As-Built Baseline Monitoring Report FINAL

Whittier Creek Mitigation Project

Subject: Response to DMS Comments for Draft MY0 Report Review
Whittier Creek Mitigation Project, Surry County
Yadkin River Basin: 03040101
DMS Project #100020, DEQ Contract #7182

Figure 5. MY0 Cross-Sections

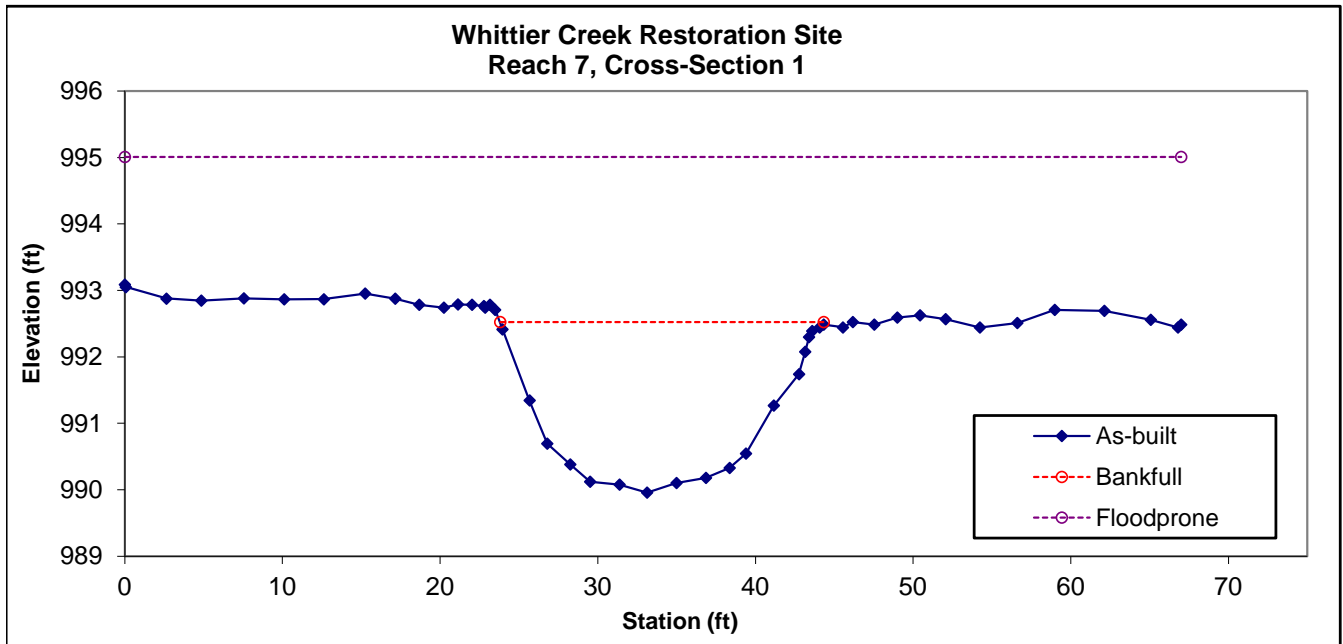
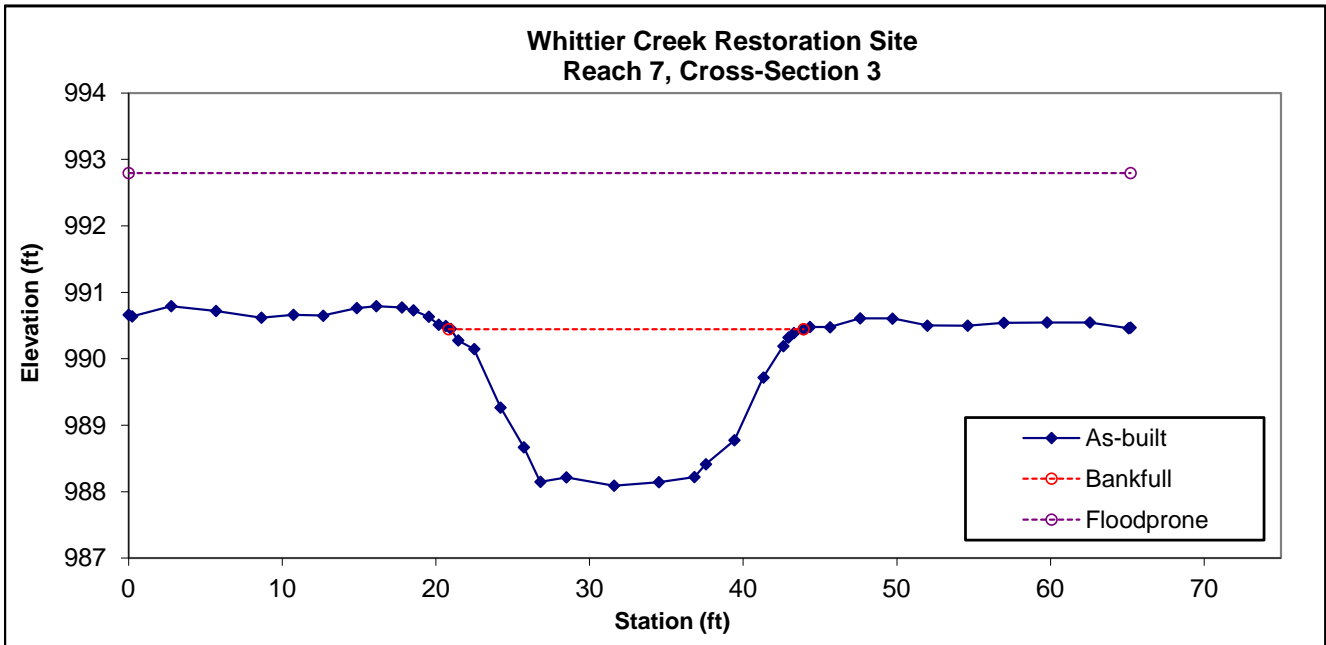
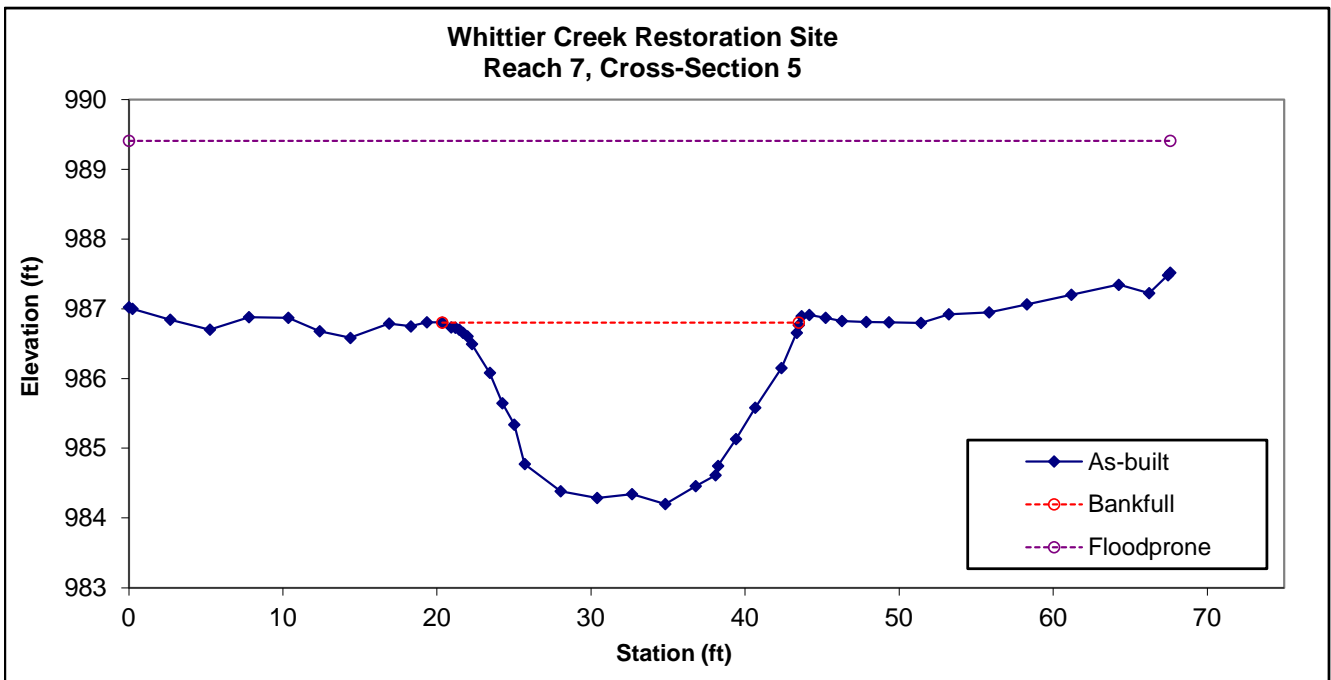
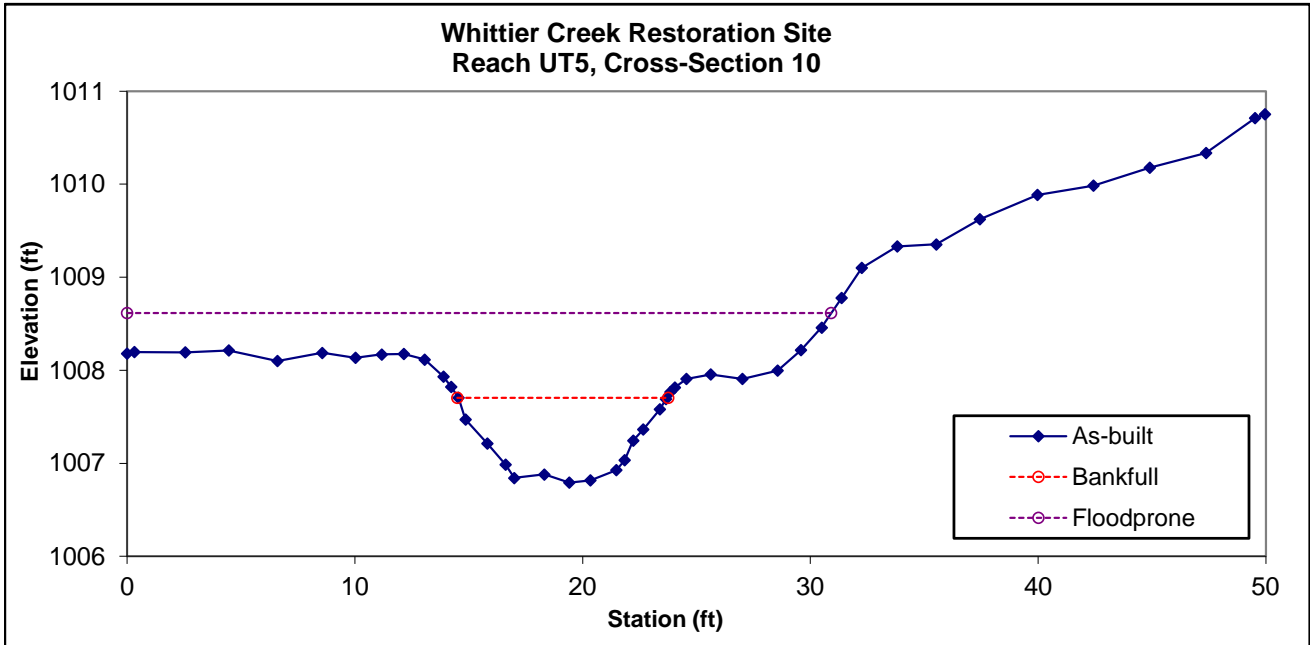
- Please review and revise cross-section entrenchment ratios. Cross-section 1, 3, 5 and 10 graphs show different values than shown on Table 7.

Response: Those values were reviewed and have been corrected so they now all match. Our apologies for the confusion.
